CHANGE ORDER NO. 6

Project: Monterey Conference Center Renovation Project, #30C1453
Including Portola Plaza Renovation Project, #30C1601

Proposal Request No. 037
Date Issued: 6/23/2016

Subject: Reinforce Gridline "K" for the "Best Fit Grid" Control Point Shift

Project No.: 210001
Drawn By: TEAM
Checked By: LEAD
Scale: 1/16" = 1'-0"
Sheet No.: **S0.01**

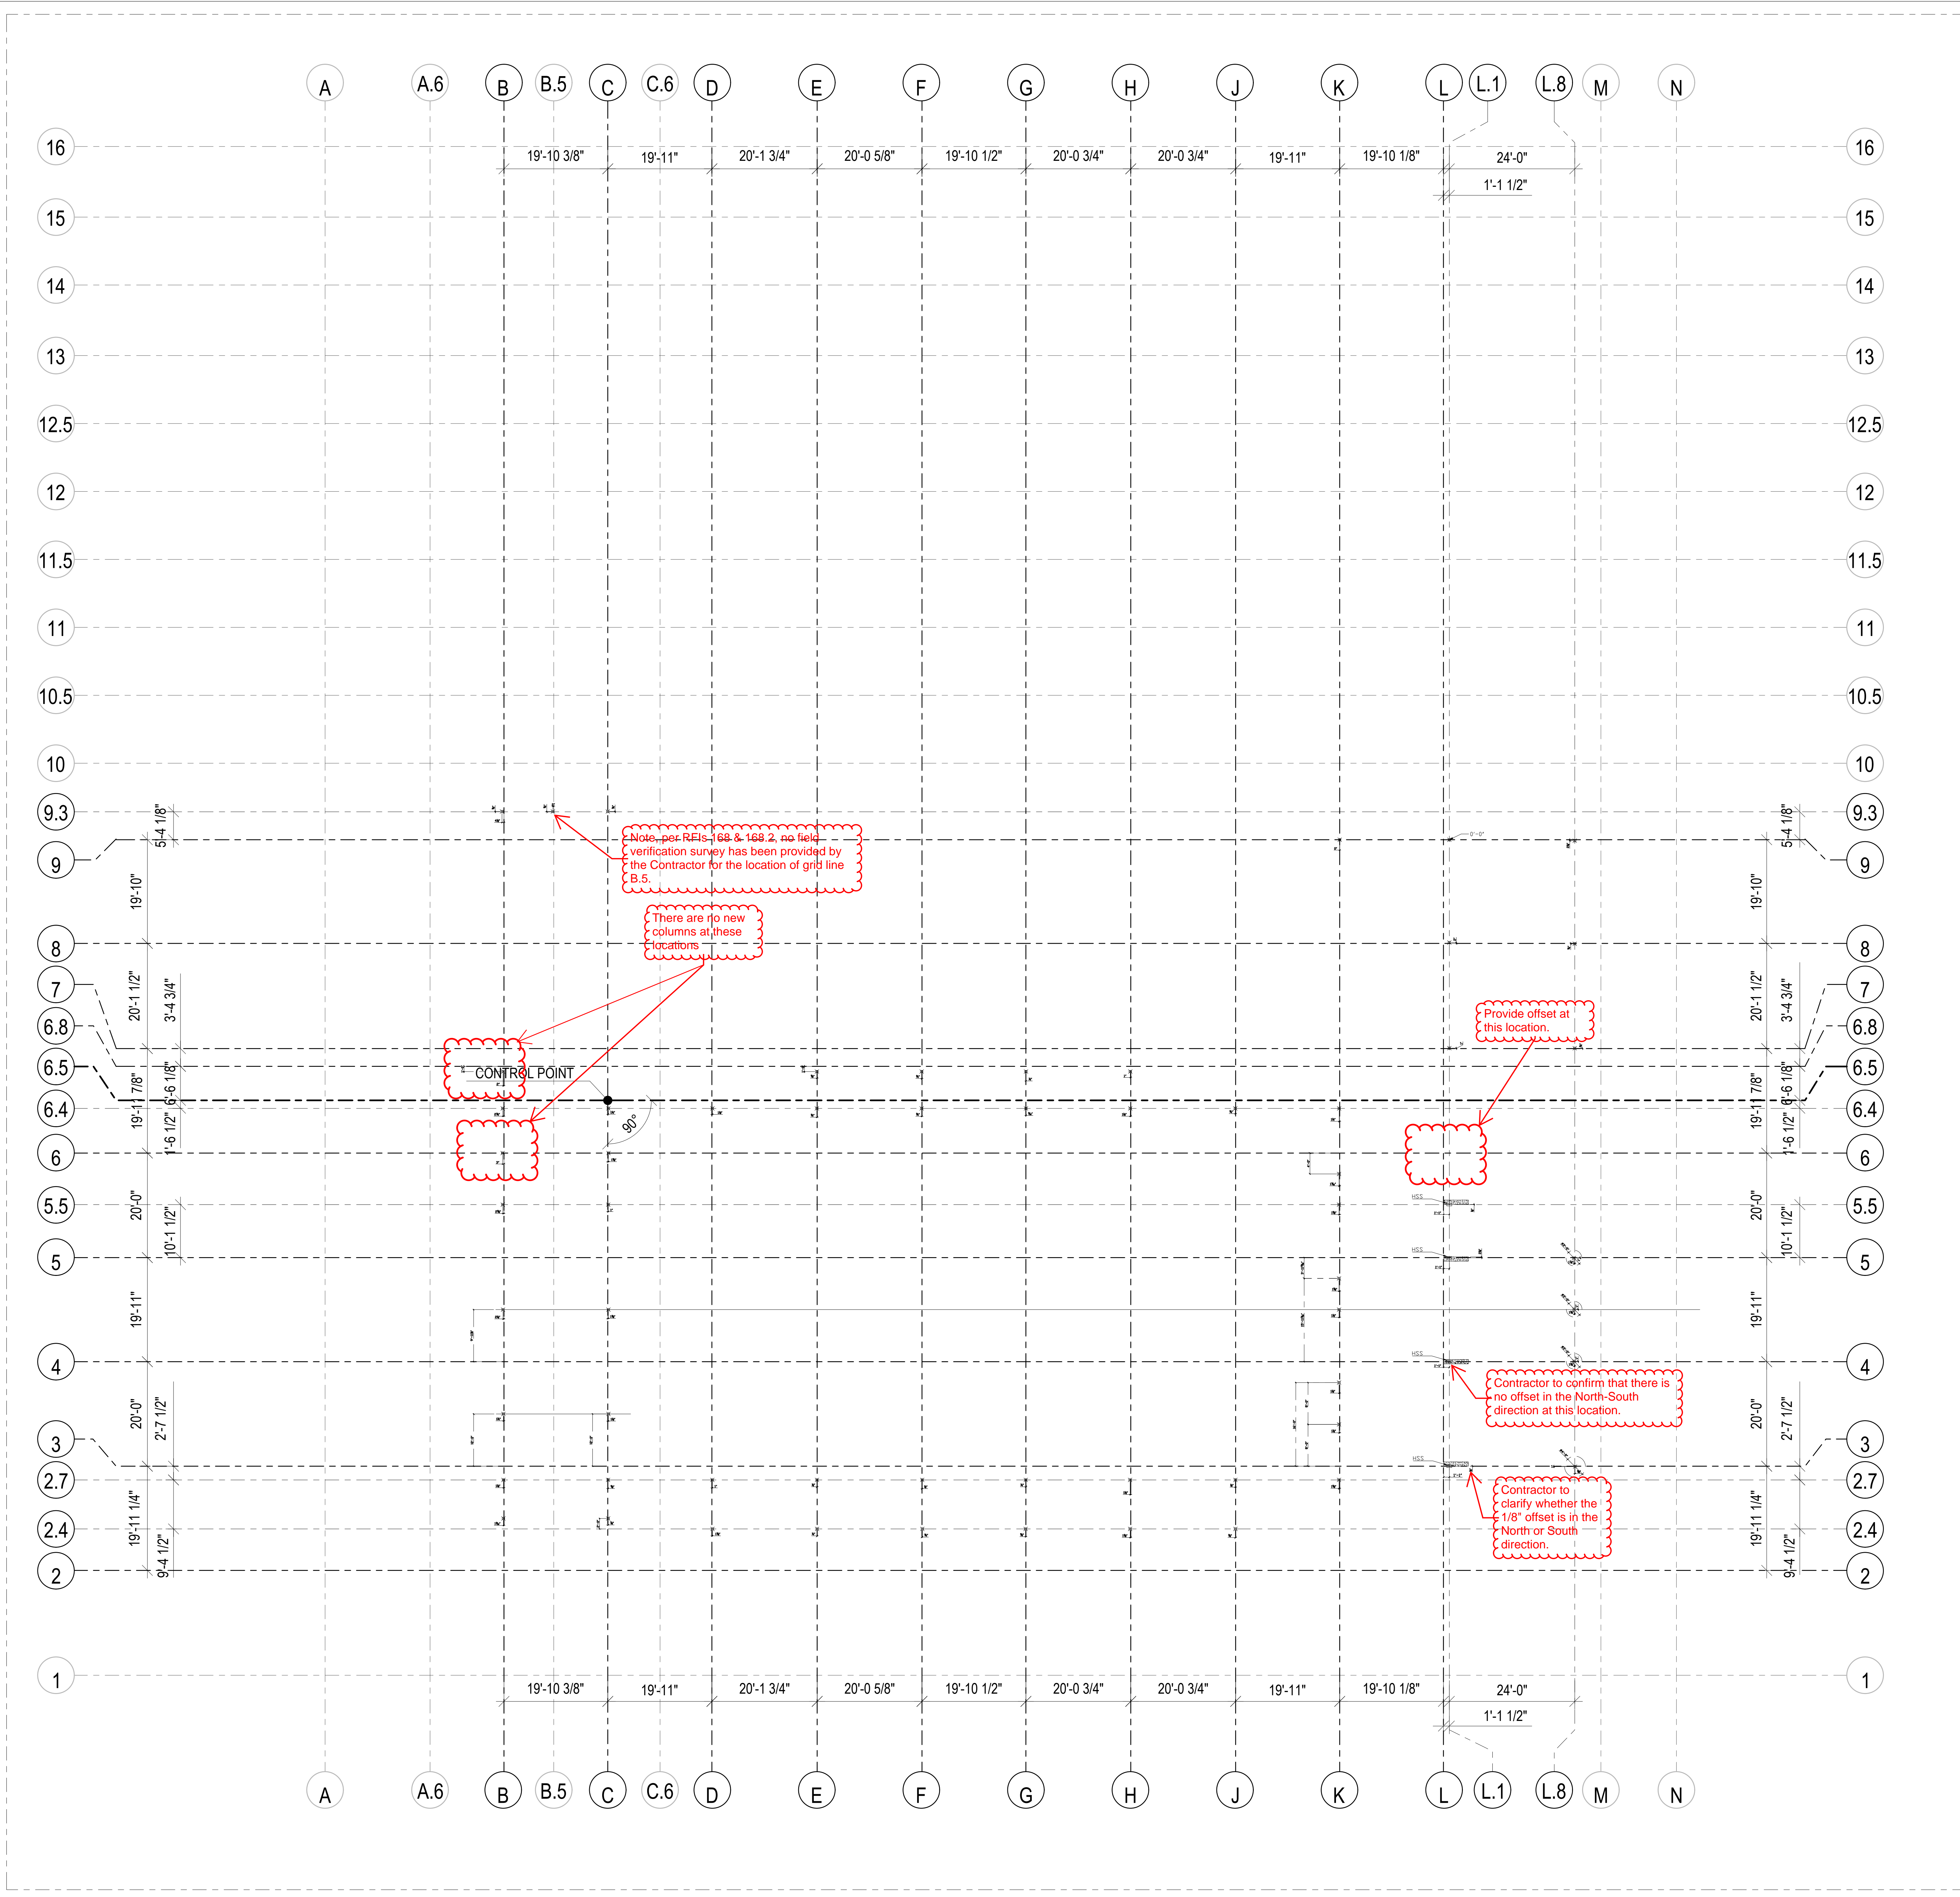
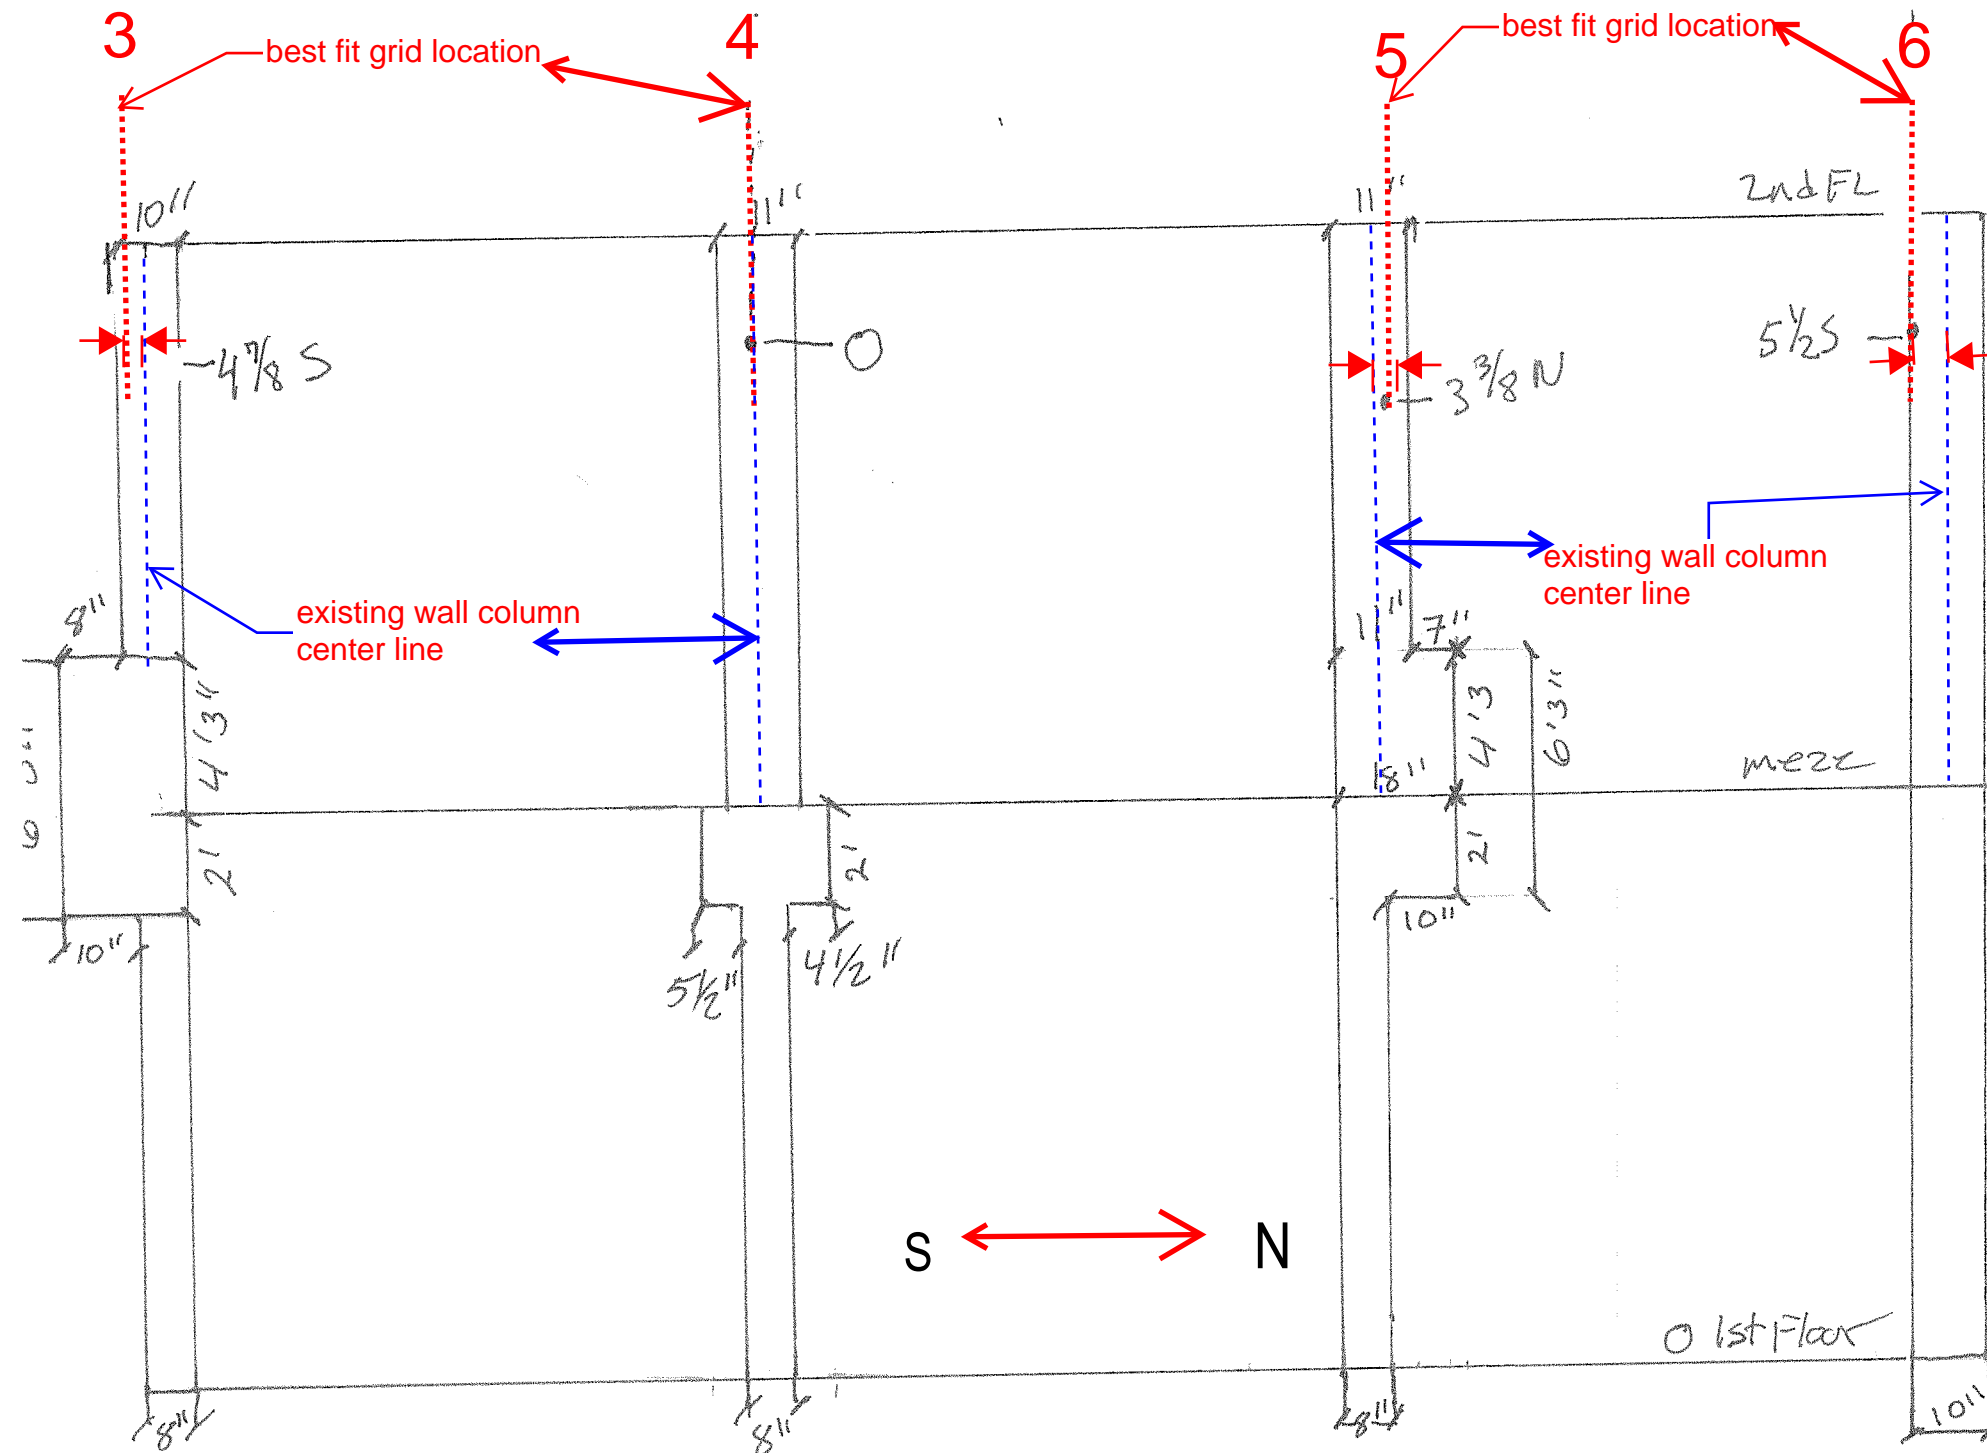
-Contractor to clearly indicate the location of the proposed control point for the layout of the best fit grid that yields the existing structure offsets provided in this RFI. Based on these existing structure offsets, the following structural elements will need to be reinforced:

Also, refer to additional comments below on the reproduction of S0.01 showing existing structure offsets.
